## RE: I WADHAM GARDENS, ST. JOHN'S WOOD, LONDON NW3 3DN

Application for full planning permission to install a new basement with front and side light-wells, together with a roof extension and alterations to the internal layout. The proposed development is in-keeping with approved application ref: 2021/6174/P. The associated supporting documentation has been updated for this current submission where required.

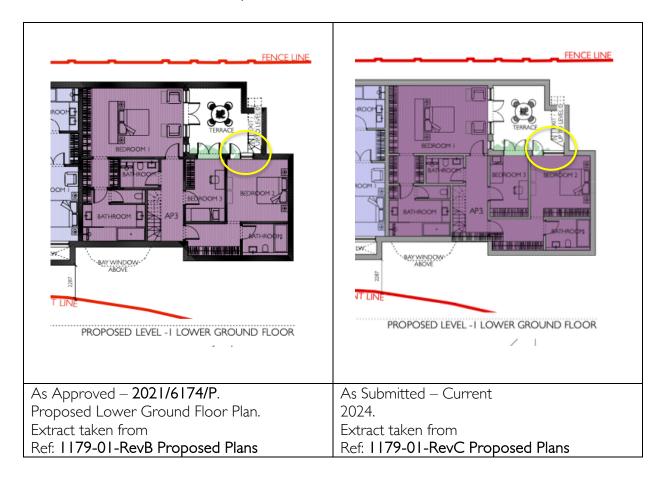
A minor update to the proposed lower ground floor plan has been incorporated for this new application to enable compliance with the current daylight and sunlight BRE guidelines which have been revised since the previous submission. Extracts of the previously approved plan and the current submission plan are included below for comparison and clarity of the change that has been made.

Bedroom 2 window made wider.

Foot of terrace staircase moved away from the Bedroom 2 window.
